## INITIAL RECOMMENDATION OF THE QUEEN ANNE/ MAGNOLIA DESIGN REVIEW BOARD

Project Number: 3007906

Address: 975 John Street

Date of Meeting: Wednesday, July 20, 2011

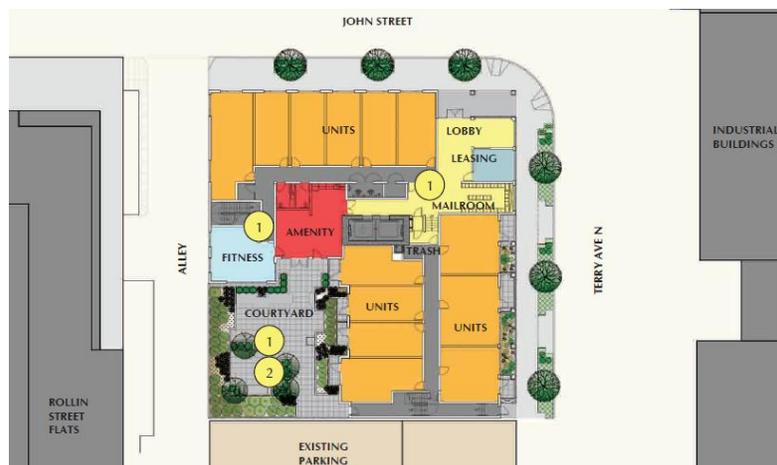
At the Initial Recommendation Meeting, the Board noted that Terry Avenue North is a pedestrian street and provides a high level of pedestrian activity between Denny Way and Lake Union, as confirmed in the Terry Avenue North Street Design Guidelines. Recent leasing activity in the area indicates that small retail spaces would be in high demand. It's important to provide an active and visually interesting street level use at this street frontage to respond to the context of the area and the development of the pedestrian corridor. The Board agreed that the proposed residential uses with private patios at the street level will not achieve the level of human activity and interaction needed at this street frontage.

The Board recommended that the street level use on Terry include a more active use, such as commercial or at the very least, residential amenity space. The design of this street level use should be consistent with the glass storefront system shown at the residential corner entry, and may include interesting materials and colors for visual interest. The Terry Ave N street frontage should include continuous overhead weather protection for pedestrians.

The Board expressed concern about the proposed use and street level design at Terry Ave N (described in response to Guideline A-4). The Board recommended a street level use at Terry Ave N that will generate human activity, and revise the street level design to include human-scale high quality durable materials with visual interest.

The Board also expressed concern about the design of the base of the building at the northwest corner. The proposed garage level was shown in finished concrete, with cementitious panel and plank above. Windows at the northwest corner would have a sill height approximately 8' above the sidewalk. The Board expressed concern about the clear visual division of the façade at the garage level and the amount of blank wall adjacent to the pedestrian experience at this corner. The Board recommended that the base of the building and the garage level should be consistently clad in a human-scaled material.
